**RE: Communication Letter of Littelfuse TPSMB series Capacity Expansion**

# PCN Report

**Prepared By** : Haipeng Xu, Senior Product Engineer  
**Date** : Apr. 30<sup>th</sup>, 2018  
**Products** : Automotive TVS in SMB(DO214AA) package acquired from ON Semiconductor  
**Revision** : A

#### a. ON Semiconductor's label [OLD]

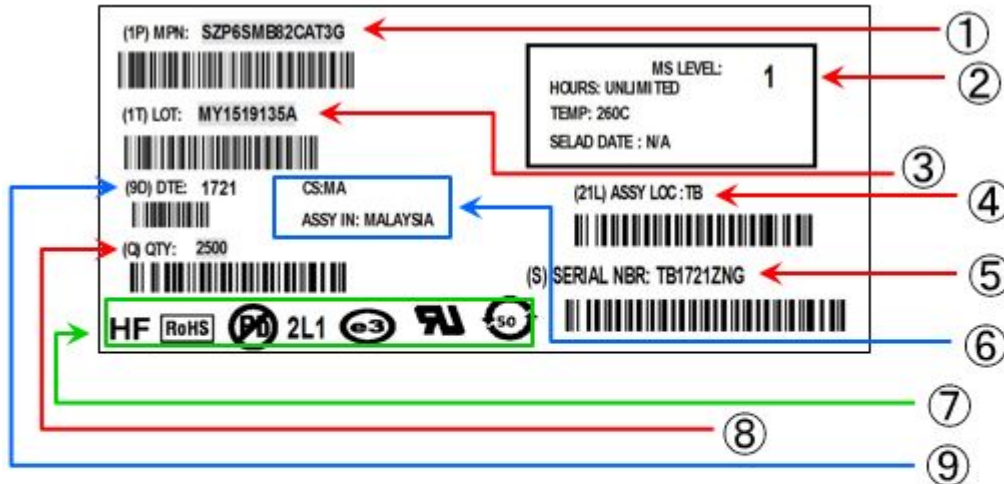
### 3.2 Label format change

- Legend:
- 1. Part number
- 2. MSL Level
- 3. Lot number
- 4. Assembly location
- 5. ON serial number
- 6. Assembly site
- 7. Compliance logo
- 8. Quantity
- 9. Manufacturing date

#### b. Littelfuse's label [NEW]

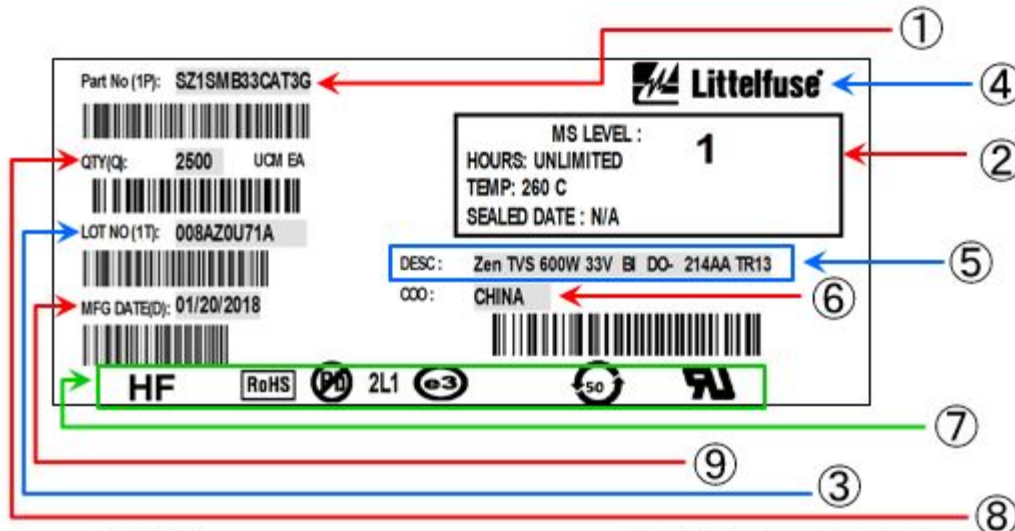
- Legend:
- 1. Part number
- 2. MSL level
- 3. Lot number
- 4. Littelfuse logo
- 5. Part number description
- 6. Assembly site
- 7. Compliance logo
- 8. Quantity
- 9. Manufacturing date
